## WLTP UNR Development (based on WLTP-28-09e)

Agreed proposals within WLTP Sub Group EV – Revision 5

Figure A8/2

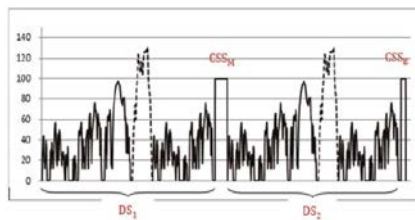
- In the referred paragraph, it is only described how to accelerate to reach the speed in the constant speed segment but it is not described how to decelerate
- Proposal adds a sentence which also describes how to decelerate from constant speed to stand still

- JPN supports the proposal
- EC supports the proposal

**The deceleration from the constant speed level shall be smooth and accomplished within 1 minute after completion of the constant speed segments.**
